# Code Compliance Certificate

| Location          | 4 STONEWALL GROVE, WAIKANAE                                           |

RESPONSES  
BELOW  
+  
AMENDED DRAWINGS  
G20, G30, G60,  
AMENDED  
SPENCER HOLMES  
DRAWING E17 0699 03  
REV A  
AMENDED CALCS  
J. Ellis  
11.5.18

Bracing Plan, upper level

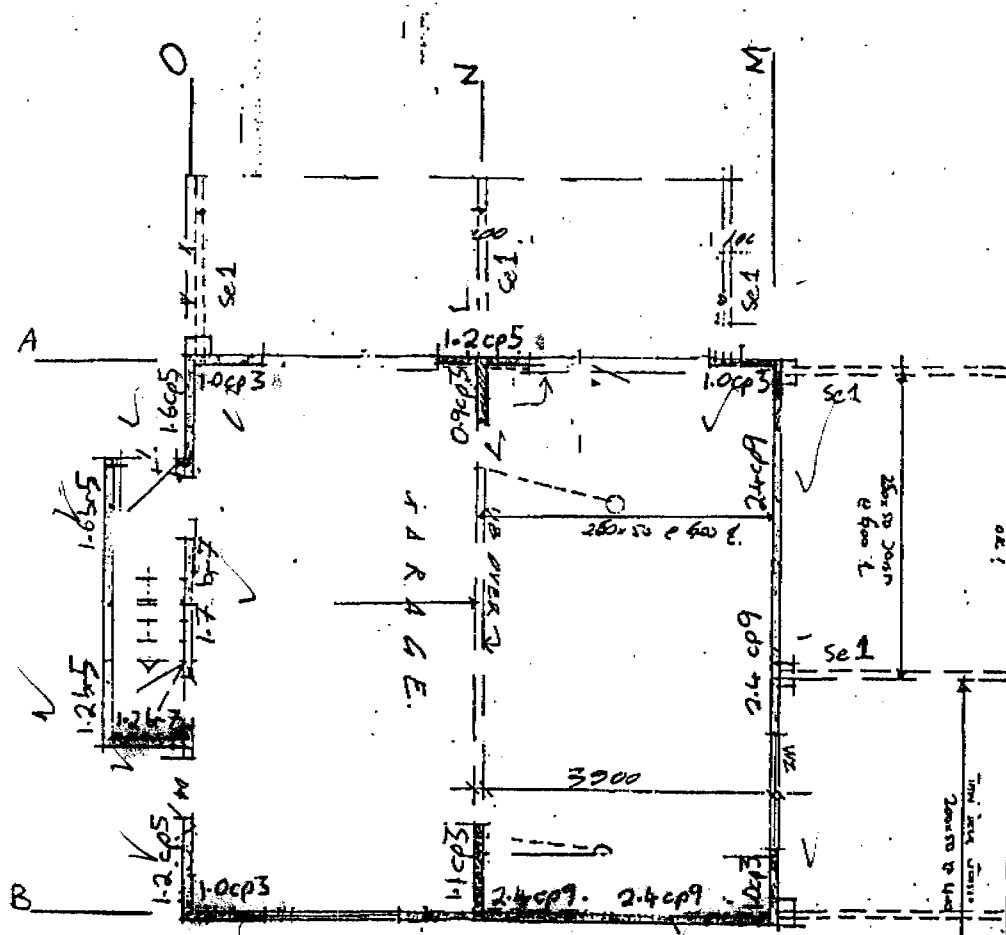
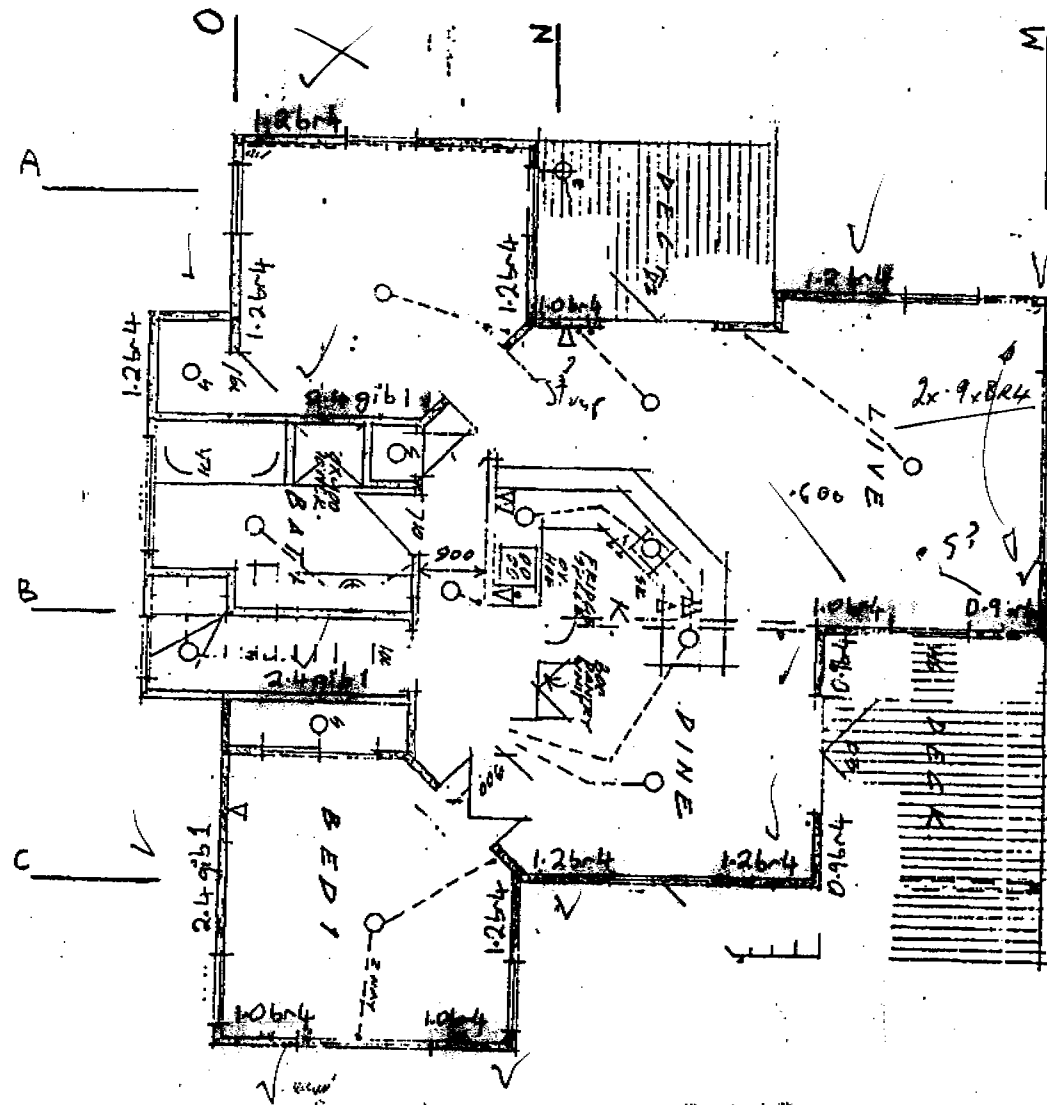
1 grouted flanged beam. fix engineer  
design against uplift

Down Bolt steel Braces 150. each end  
stairs + strap

Bolt framing to R.S.J. North end.  
Solid blocking 3.8 x 39.

6.3  
5/18 REVISION C

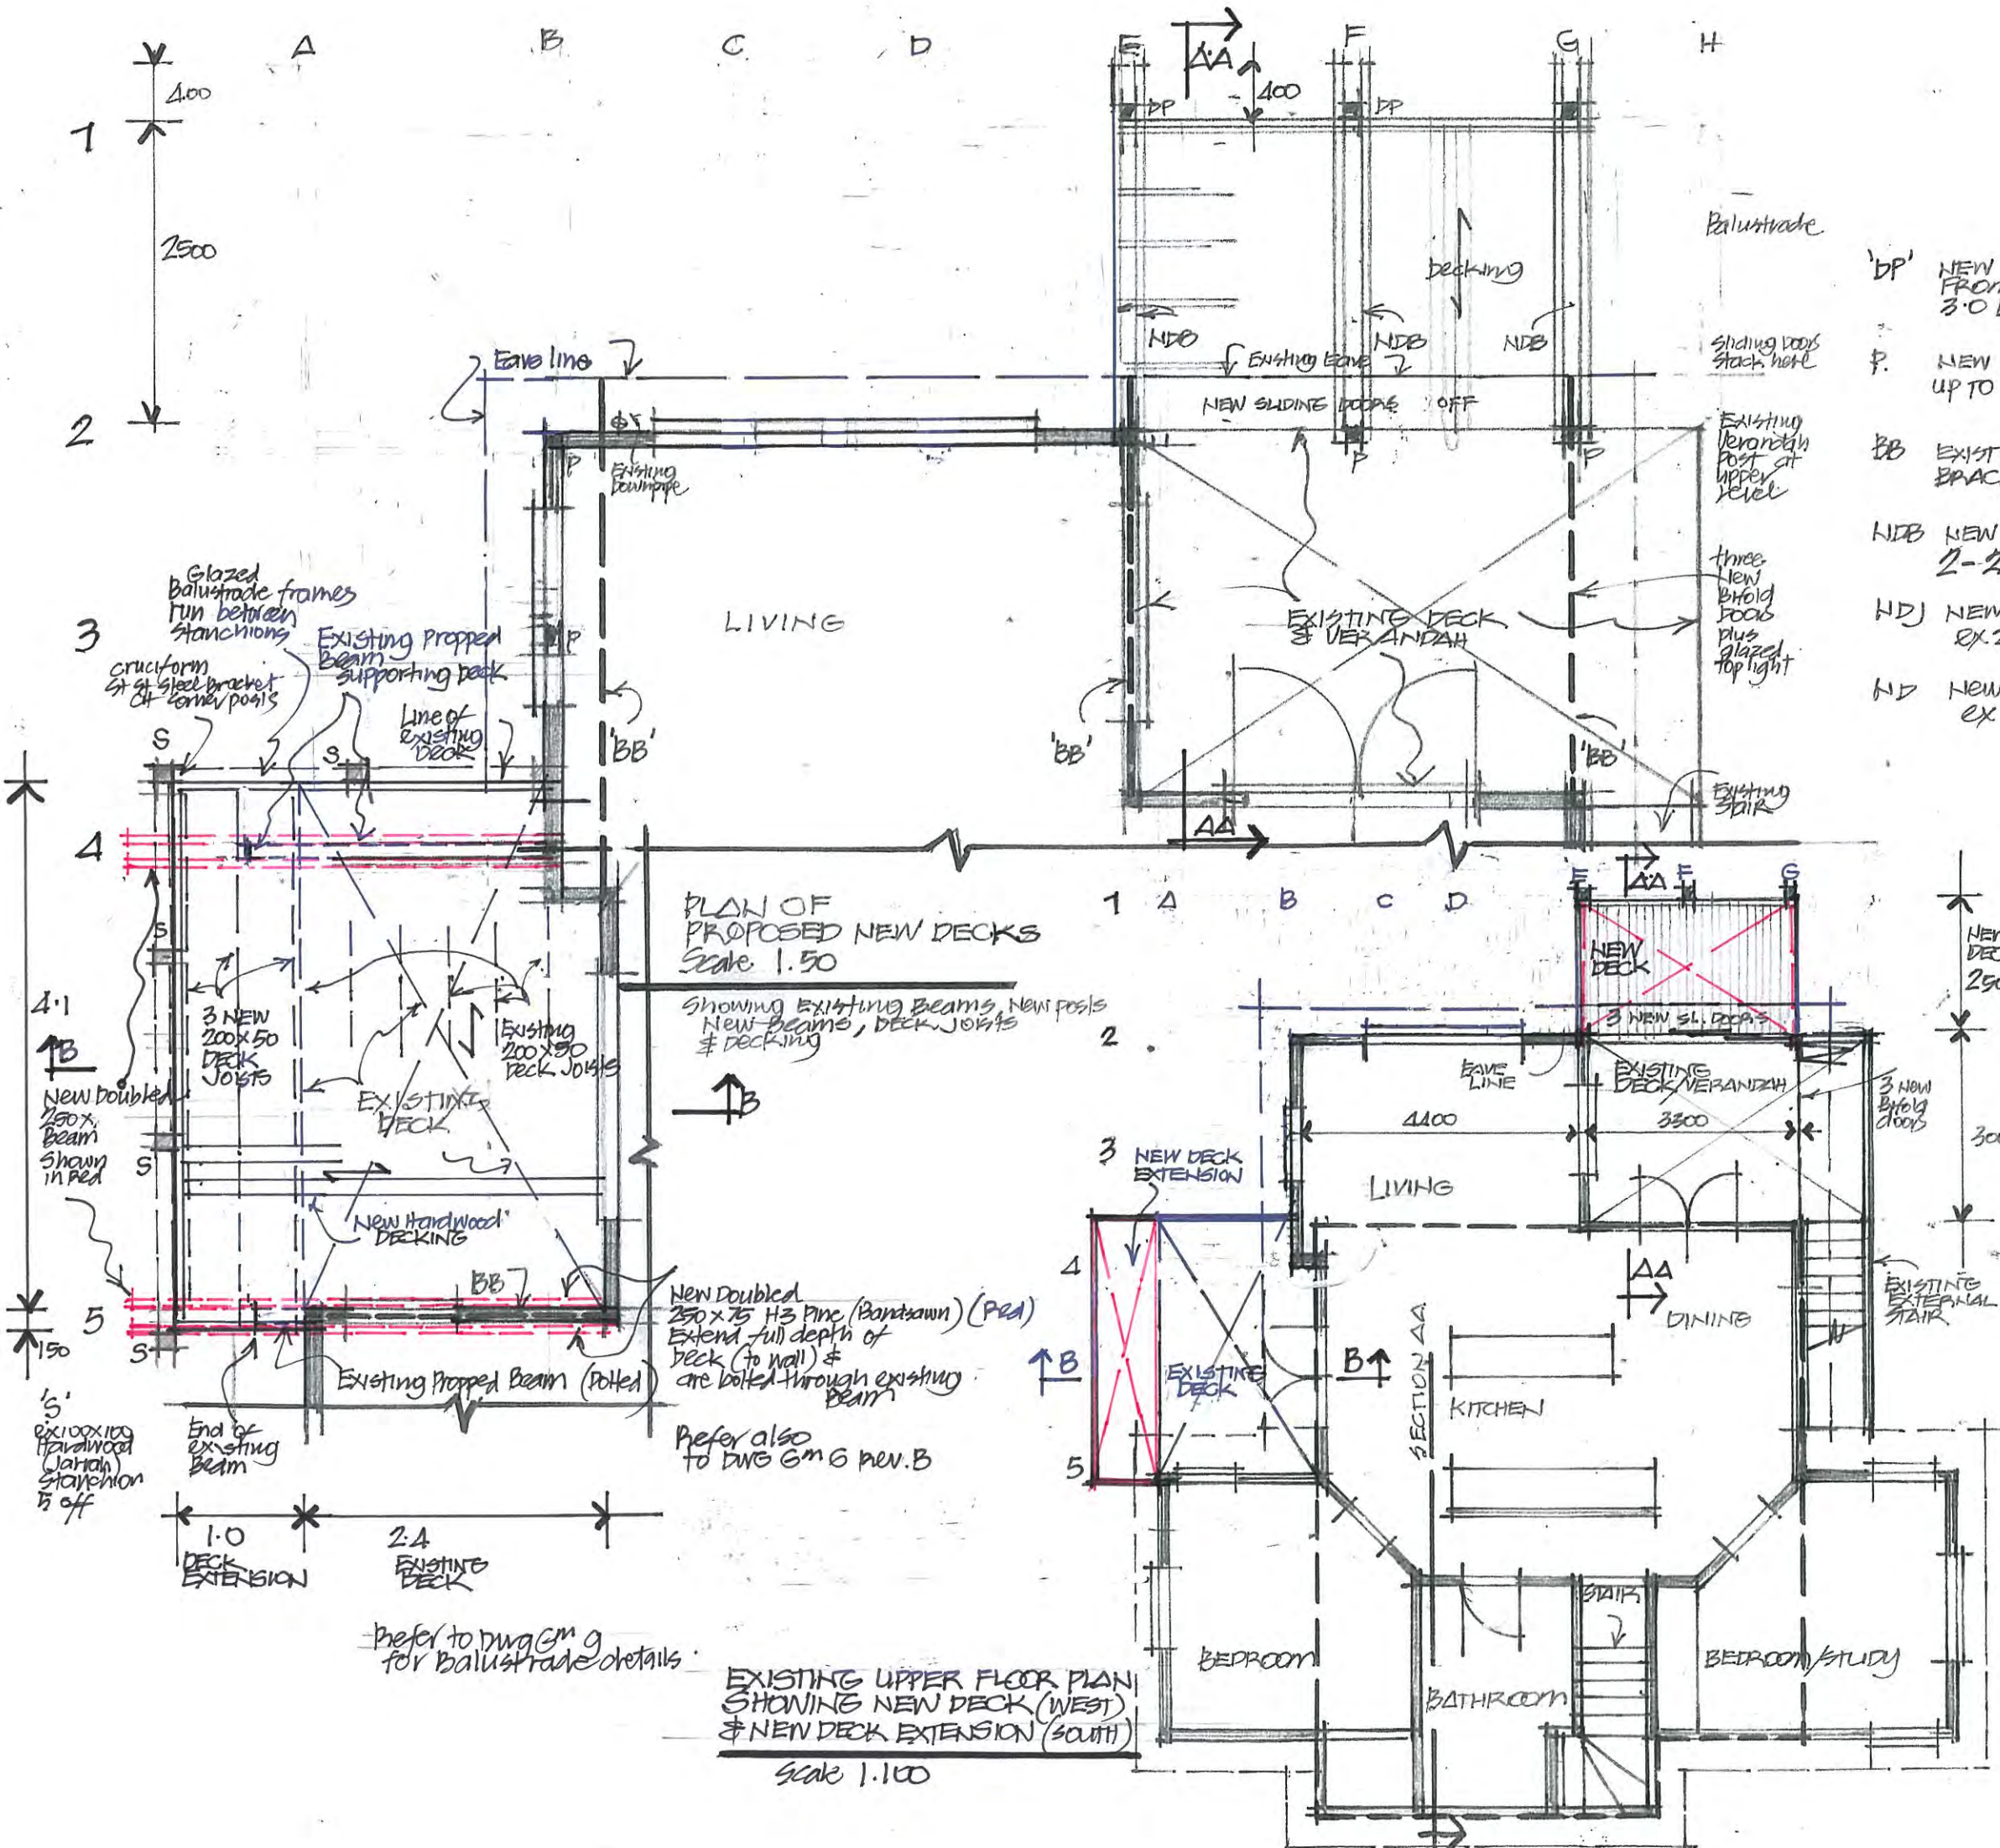
- re: north east elevation. the deck balustrade is shown with no intermediate barrier post i.e the barrier is 2.5 metres long. the engineers calculations limit the barrier posts centres to 1.5 metres. Please revise accordingly. **REFER TO DWG G 3 REVISION C - ADDITIONAL BARRIER POSTS**

REV.  
G<sup>m</sup> 6 5/18 C

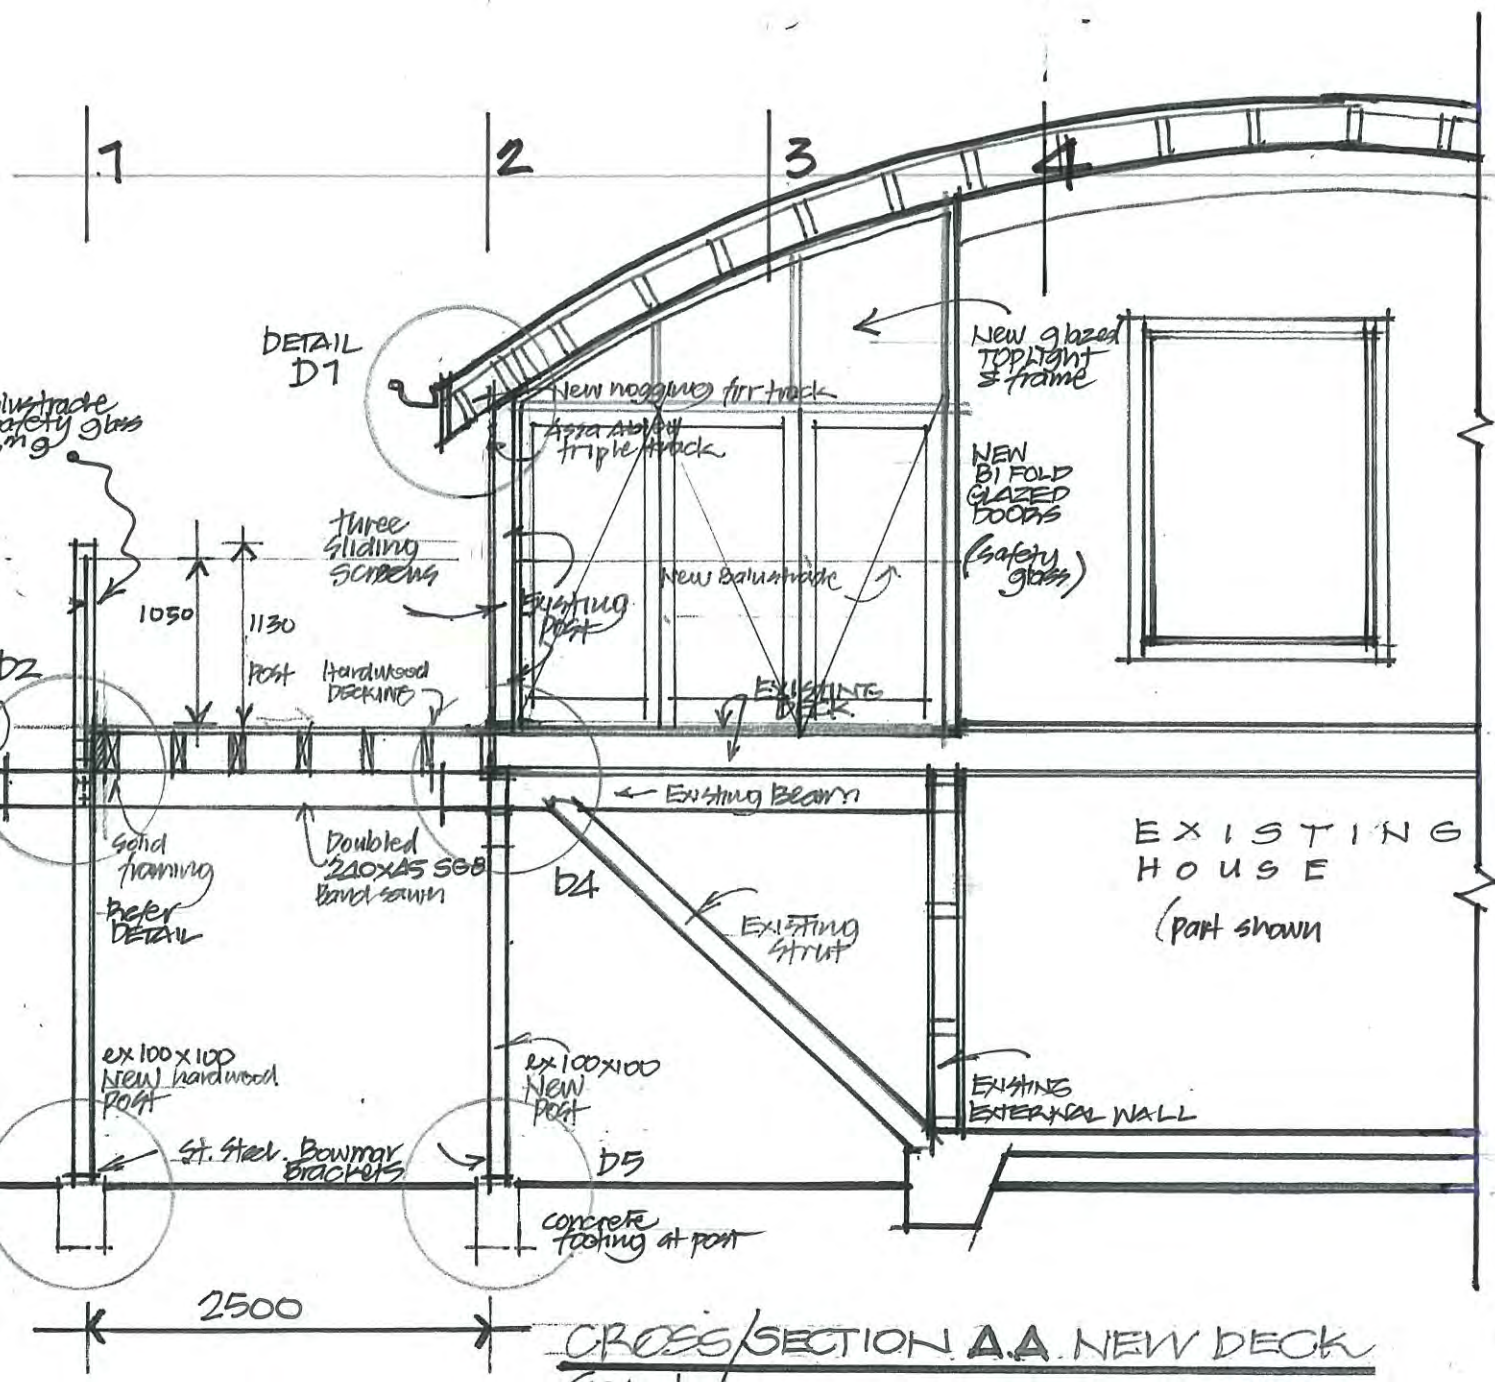
- Please confirm which type of balustrade will be used, timber framed with laminated glass in fills or metro glass frameless. **JARRAH TIMBER POSTS WITH TIMBER INFILL FRAMES & LAMINATED TOUGHENED GLASS. SEE CORRECTED DWG G 6 REV. C.**  
If metro is to be used please provide the producer statement and specifications for this to demonstrate compliance with clause B1 (Not Applicable)
